Product discontinuation information

PCN No.:	IBF180002	Date:	05.02.2019
Products:	HEAVYCON metal housings D15, D25 and D50 with powder coating

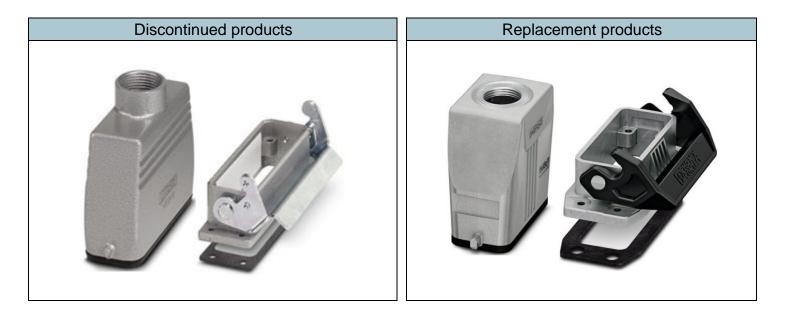
For the replacement products, a corrosion-resistant aluminum alloy was used. This renders an additional surface finishing (paint) superfluous. Thanks to this and to the use of conductive seal elements, the replacement products are EMC suitable. With IP66/67, the new housings feature higher degrees of protection (the discontinued products only featured IP65).

Instead of a metal locking latch, the replacement products have an all-plastic latch made of glassfiber-reinforced polyamide, as this solution offers mechanical and haptic advantages.

The drilling and wall cut-out dimensions of the replacement products match those of the discontinued panel mounting frames and surface mounting housings.

Discontinued and new housings are mating compatible. The previously used housings can still be used.
